Our Ref: 2001w-SEC-00003-02

28th April 2017

RESPONSE NOTE TO COMMENTS MADE BY THE ARUN DISTRICT COUNCIL (ADC) EHO ON THE PLANNING APPLICATION FOR THE PROPOSED DEVELOPMENT AT CLYMPING

FIGURE A1: PROPOSED DEVELOPMENT LAYOUT

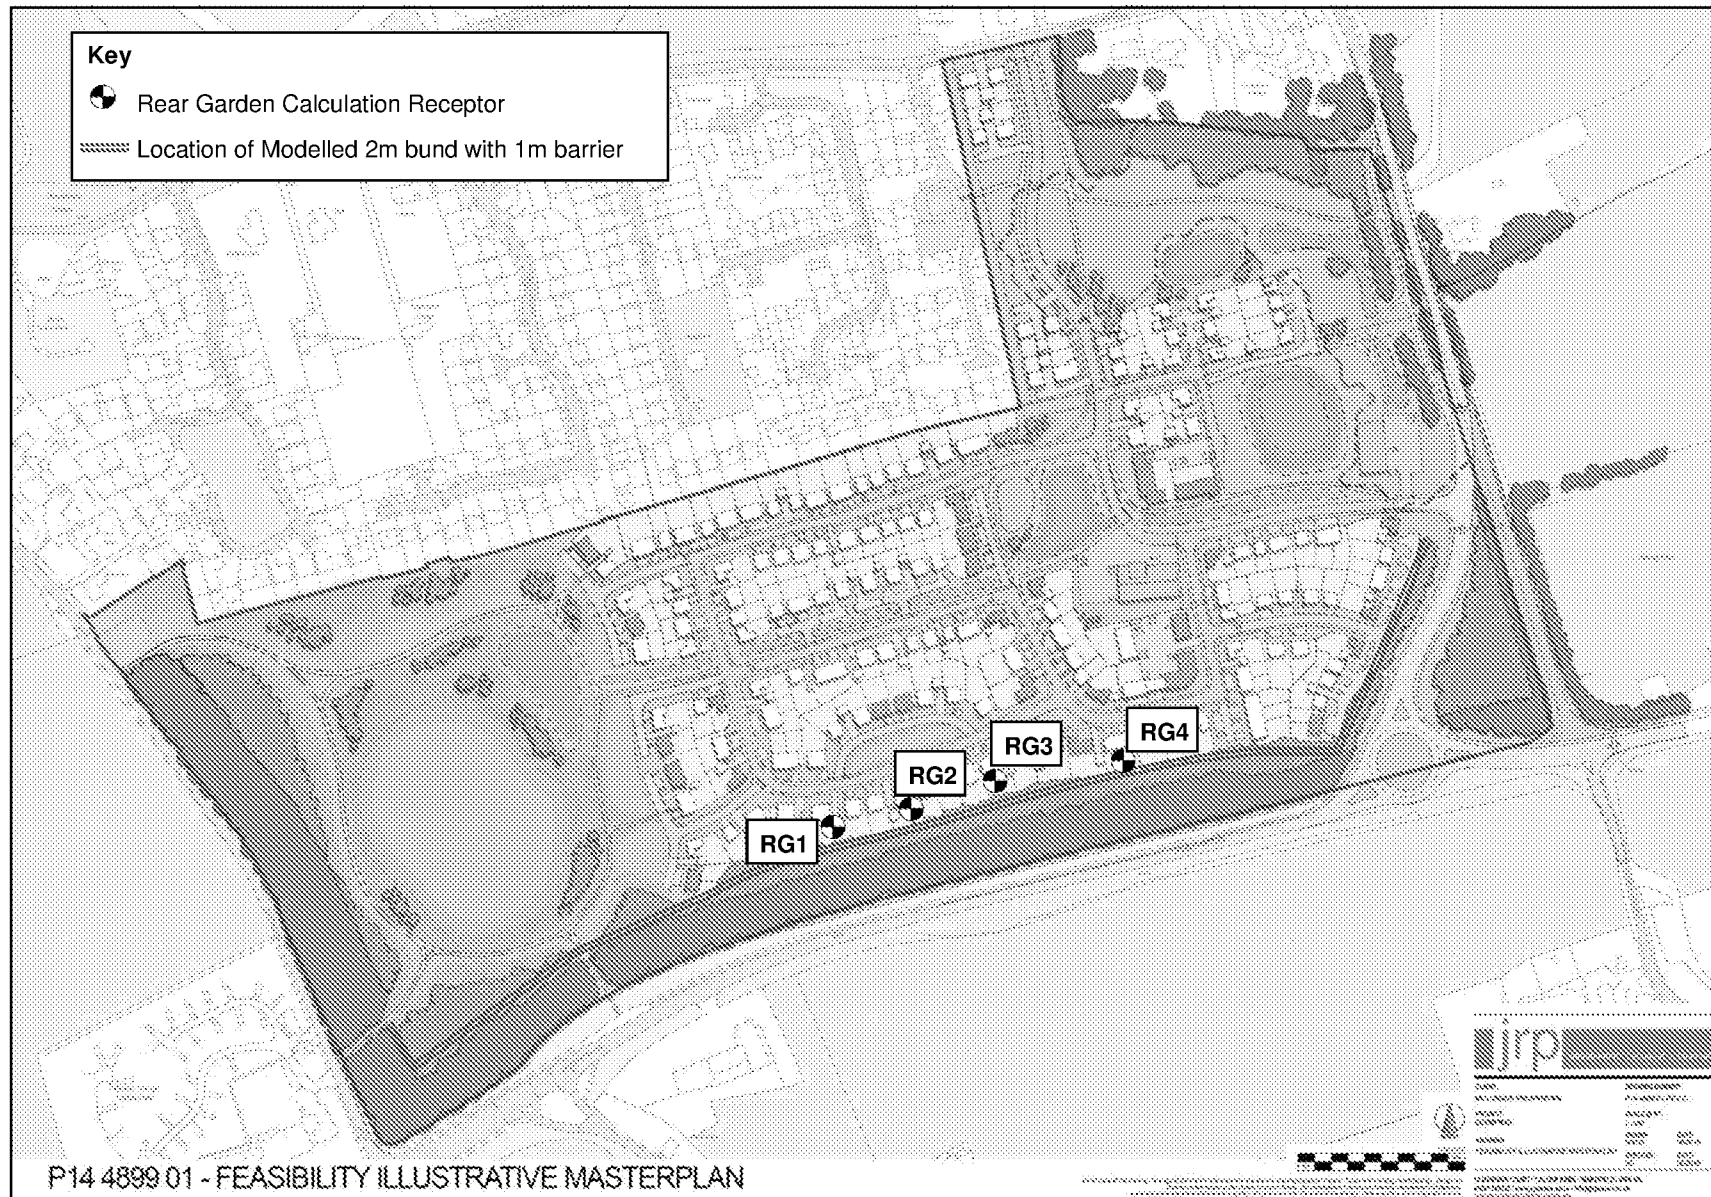
“Please could you ask the applicant to confirm the location and extent of the 1.8m high garden fencing on the boundary of the southernmost proposed properties? Similarly, please could they provide the location and extent of the proposed 2m roadside bund with 1m barrier on top?”

Based on the Masterplan we have assumed that the fence line will be along the southern boundary and the bund to be adjacent to the A259. The illustrative Masterplan, with an overlay of the proposed bund and barrier is shown in Figure A1 of Appendix A of this report.

FIGURE A2: LAEQ,16HR CONTOUR PLOT (FREE-FIELD) AT 4M HEIGHT SHOWING FIRST FLOOR OF DWELLINGS PREDICTED TO ACHIEVE OR EXCEED THE 35 dB LAEQ,16hr DAYTIME RESTING CRITERIA IN BEDROOMS, WITH FUTURE TRAFFIC CONDITIONS

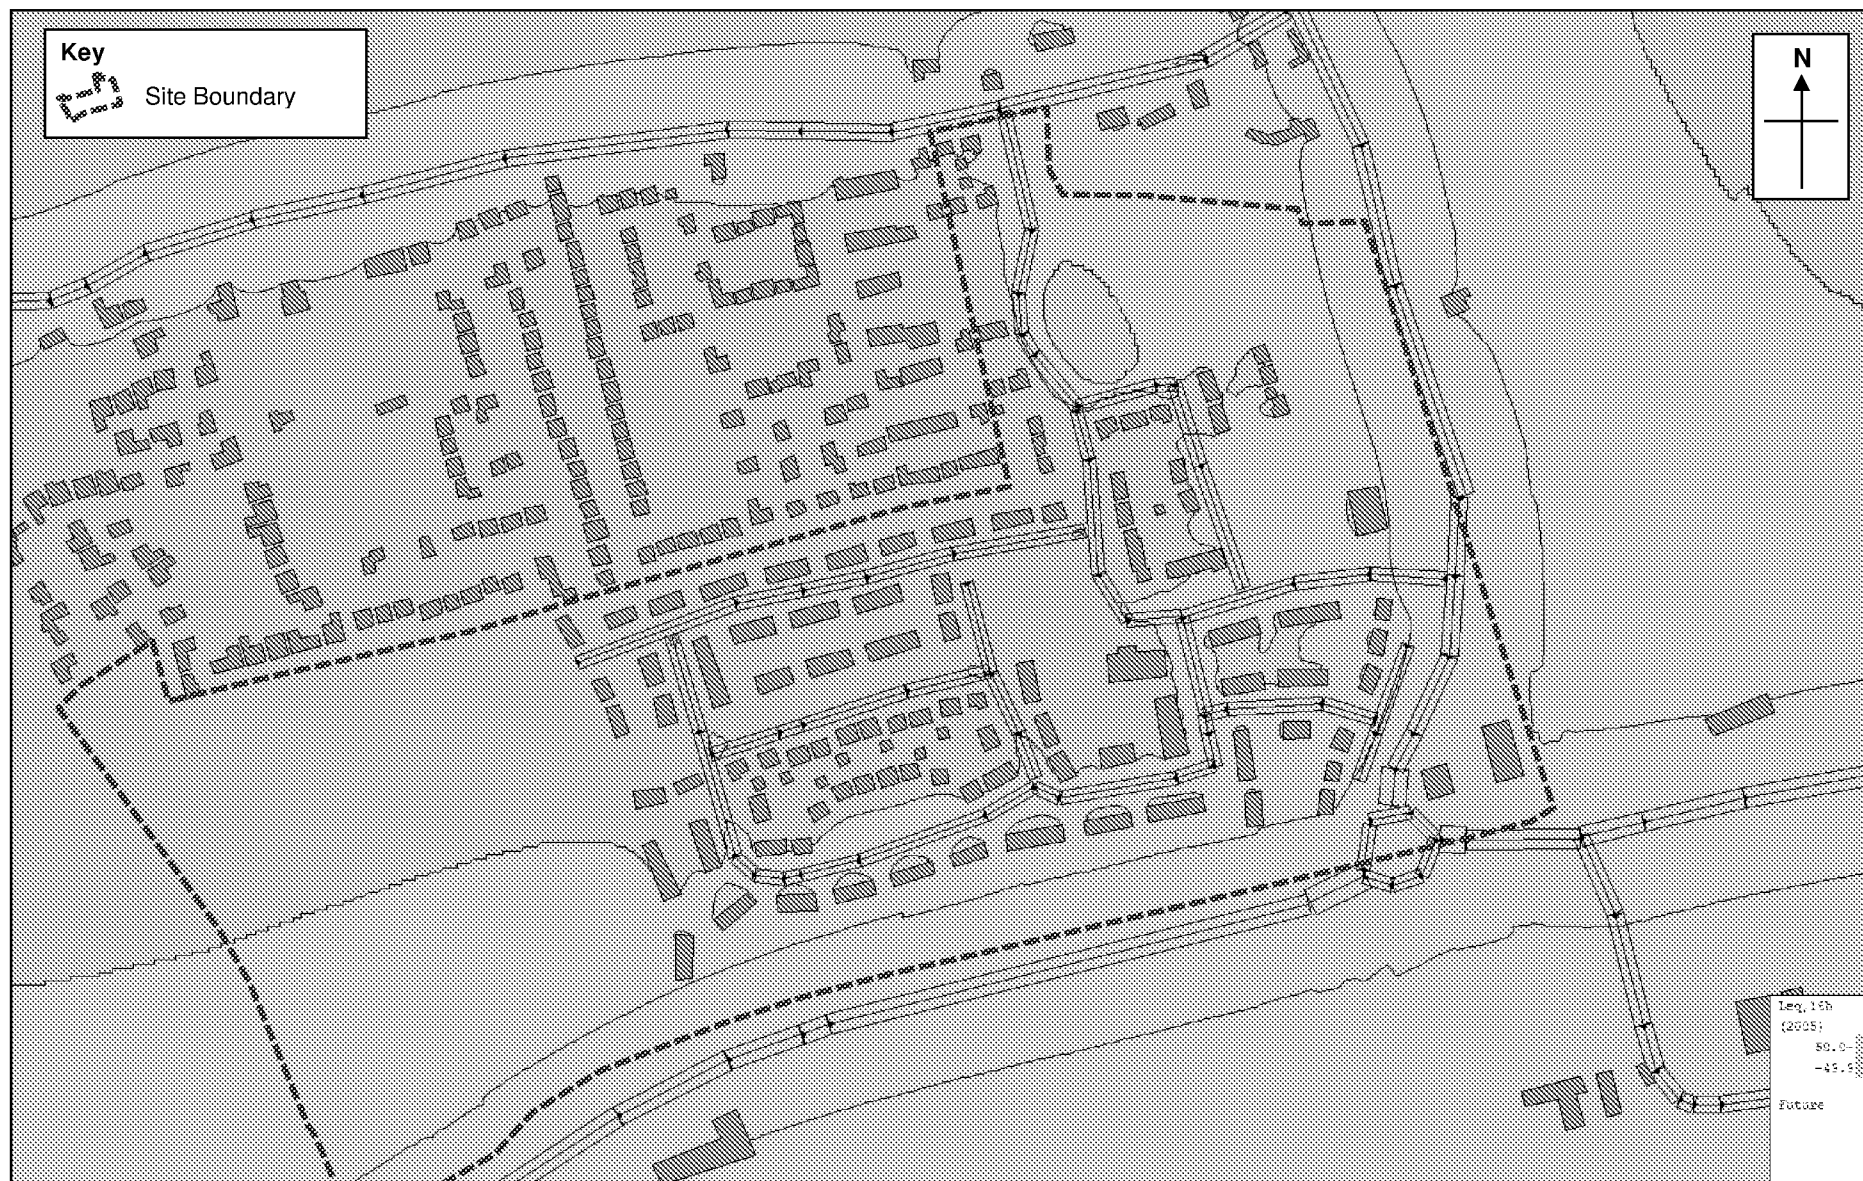
“As stated in my previous email of 28th February, with windows partially open, the 35dB(A) criterion is exceeded by up to +10dB LAeq (16 hour) in the daytime and up to 9 dB LAeq (8 hour) at nighttime. I appreciate that the report suggests mitigation for this including sound attenuating ventilators in the window units, acoustic air bricks in the façade, passive whole house ventilation or mechanical silenced ventilation. However, I would question how realistic it is to expect future residents to not open the windows in a rural environment such as this one. If this application is given permission, I would strongly recommend that a condition requiring acoustic testing of each dwelling prior to first occupation is placed on the permission, to ensure that the stated levels can be reached”.

With regards to expecting residents to not open the windows, the windows on other facades can be opened and the design of the dwellings and their orientation in relation to the A259 and the layout has been adapted to take the noise levels from the A259 into account. The noise contour showing where alternative ventilation and/or alternative layouts may be required is shown in Figure A2. This contour shows the spread of free-field road traffic noise across site, at a height of 4m above ground (representative of 1st floor window height). An illustrative layout of the upper floor bathrooms, corridors and stairwells on the noisier southern and eastern facades and the bedrooms on the quieter facades is shown in Figure A3.

The contour shows that there is a mixture of properties that are predicted to either achieve or exceed the internal noise guideline value of 35 dB $L_{Aeq,16hr}$. Typically the properties that are predicted to achieve the guideline value are positioned away from the main roads to the east and south.

Almost all of the proposed residential properties achieve the guideline value on either the front or rear façade. As such, careful planning of the building layouts should ensure that sensitive rooms have façades that are predicted to achieve the guideline value. A small number of proposed dwellings where both of the main facades are predicted to exceed the internal guideline value of 35 dB are located either in the south east corner of the proposed development.
